From: [REDACTED]
To: [Emi Sugiyama](#)
Subject: [City of Cupertino] Assignment: Technical Concern: Cumulative Evacuation System Failure on the Linda Vista Corridor (re: Evulich Court Project)
Date: Monday, March 2, 2026 7:52:28 AM
Attachments: [Technical Rebuttal to Hexagon Transportation Analysis.pdf](#)
[Letter to Assistant Chief Hector Estrada.pdf](#)
[260224 PC Public Hearing - Emergency Evacuation, Evulich Project .pdf](#)
[Evacuation Traffic Model and Analysis.pdf](#)

To: Assistant Chief Hector Estrada, Santa Clara County Fire Department
CC: Cupertino City Council & Clark, Cupertino Planning Commissioners & division, Mercury Newspaper, Alice Lin and Frank Swanson
From: DerChang Kau
Date: Feb. 27, 2026
Subject: Technical Concern: Cumulative Evacuation System Failure on the Linda Vista Corridor (re: Evulich Court Project)

Impacts of 2025 CAL FIRE FHSZ Classifications on Project “Evulich Court”

Include 2024 re-zoning of Evulich Ct., a.k.a. 10857~10887 Linda Vista Dr to R3 (51 units in red box)

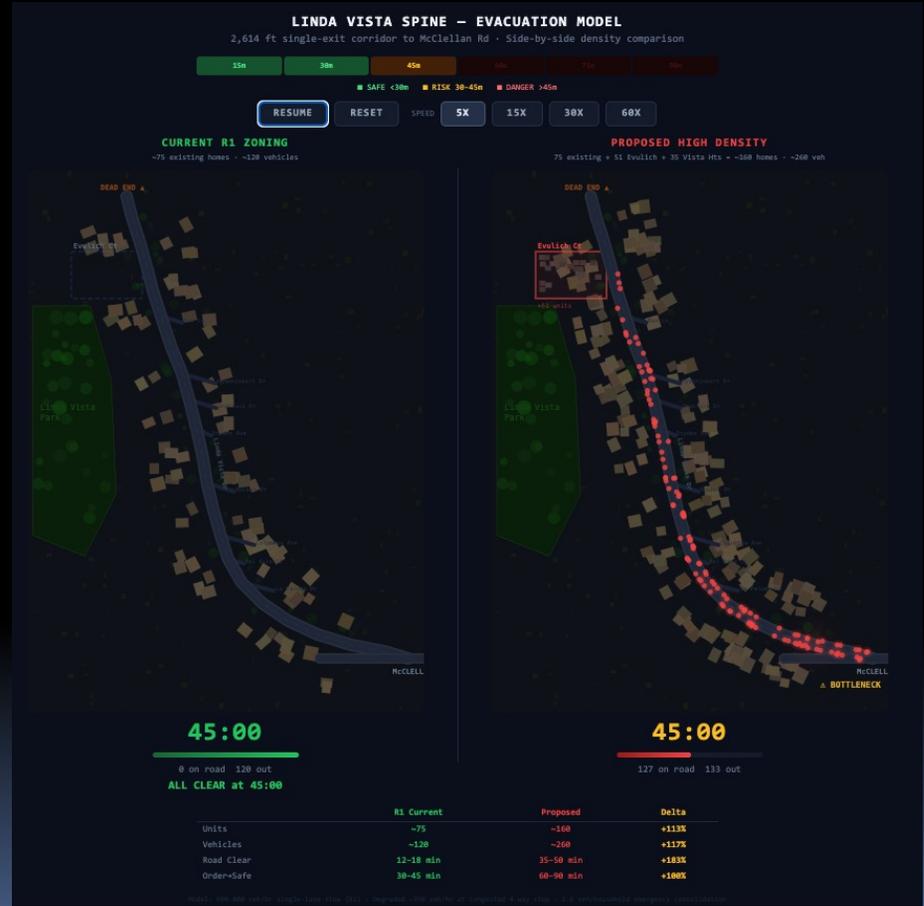
For example, Evulich Ct. is evaluated using its existing **4-unit R1 zoning**, rather than the **51-unit R3 density** under the rezoning. Consequently, **Figure HS-3** in Chapter 7 of the *Health and Safety Element / General Plan (Community Vision 2015–2040)* does not identify this area as required under **Policy HS-2.13**, which highlights residential parcels with fewer than two ingress/egress routes.
